MANDATORY SERVICE BULLETIN

DATE: August 31, 2005 Service Bulletin No. 548A
(Supersedes Service Bulletin No. 548)

SUBJECT: Diaphragm-Type Fuel Pump Inspection/Replacement

MODELS AFFECTED: New, rebuilt and overhauled engines from Lycoming with fuel pumps P/N LW-15399, LW-15472, LW-15473, and LW-16335 shipped between February 1, 2000 and September 15, 2005. Engine models affected are O-235; O-290; O-340; (L)O and IO-320, -360, -540; AIO-320, -360; AEIO-320, -360, -540; HO-360; HIO-360; and TO-360.

Figure 1

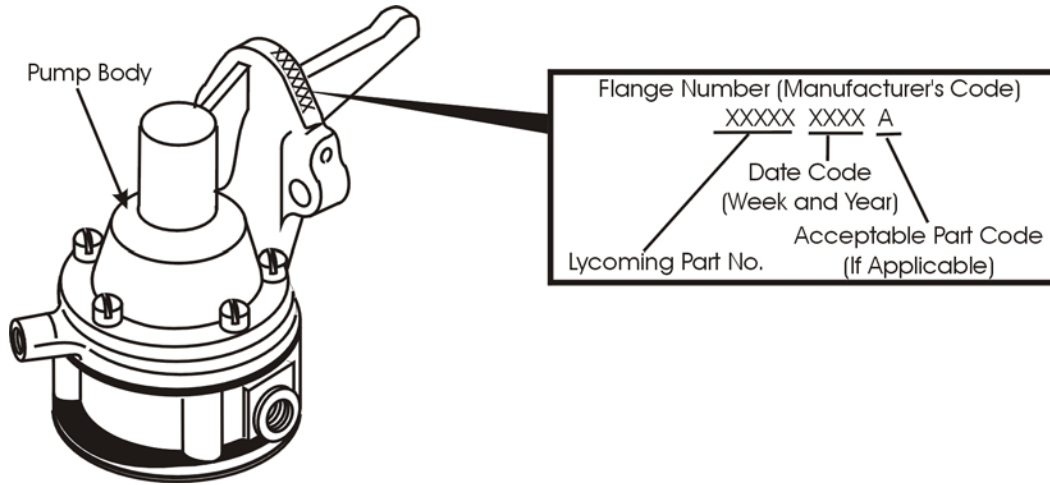
To identify affected pumps, check the manufacturer's code scribed on the flange of the pump (See Figure 1). If the first five digits are 15399, 15472, 15473, or 16335, and the 6th through 9th digits are 0700, 0800, 1100, 1200, 1300, 1400, 1500, 1600, 1800, 2000, 2100, 2200, 2300, 2400, 2800, 2900, 3000, 3100, 3200, 3300, 3400, 3500, 3600, 3700, 3800, 3900, 4000, 4100, 4200, 4300, 4400, 4500, 4600, 4700, 4800, 4900, 5000, 5100, 5200, 0101, 0201, 0301 or 0401, the pump is affected and must be replaced.

If the letter “A” is marked as a suffix to the date code, the pump has been brought into conformity and need not be replaced.

If your Lycoming engine has a diaphragm-type fuel pump with Lycoming P/N LW-15399, LW-15472, LW-15473, or LW-16335 installed, and has a date code of 0700 through 0401, the pump must be replaced within the next 100 hours of operation or 180 calendar days from the date of this Service Bulletin, whichever occurs first.
